In reply please quote: SSD-54822478

Advice on SSD-54822478 – Warehouse and Distribution Centre on Lot 14A of Gazcorp Industrial Estate (813-913 Wallgrove Rd, Horsley Park)

Gazcorp Industrial Estate – 813-913 Wallgrove Road, Horsley Park – SSD 5248 Mod 5 changes to Lot 20 site layout

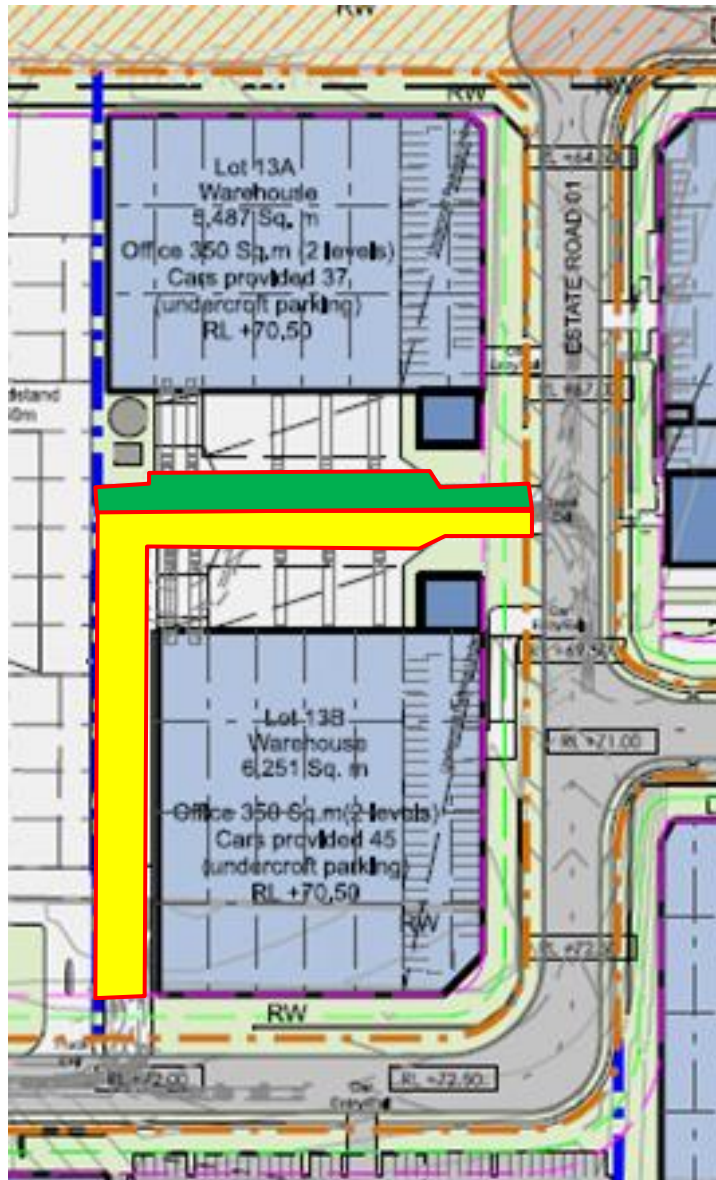
There will need to be a 'Right of Carriageway' easements created that benefits proposed Lot 13A, giving legal access over proposed Lot 13B. The trucks will need to manoeuvre over Lot 13A when parking or exiting the premises.

As per the following figure (over page), the area highlighted in 'Yellow' allows Lot 13A to enter Lot 13B via 'Estate Road 1', manoeuvre over Lot 13B to Lot 13A, and then exit onto 'Estate Road 1'. The area highlighted in 'Green' also requires a 'Right of Carriageway' easement that benefits proposed Lot 13B, giving legal access over proposed Lot 13A.
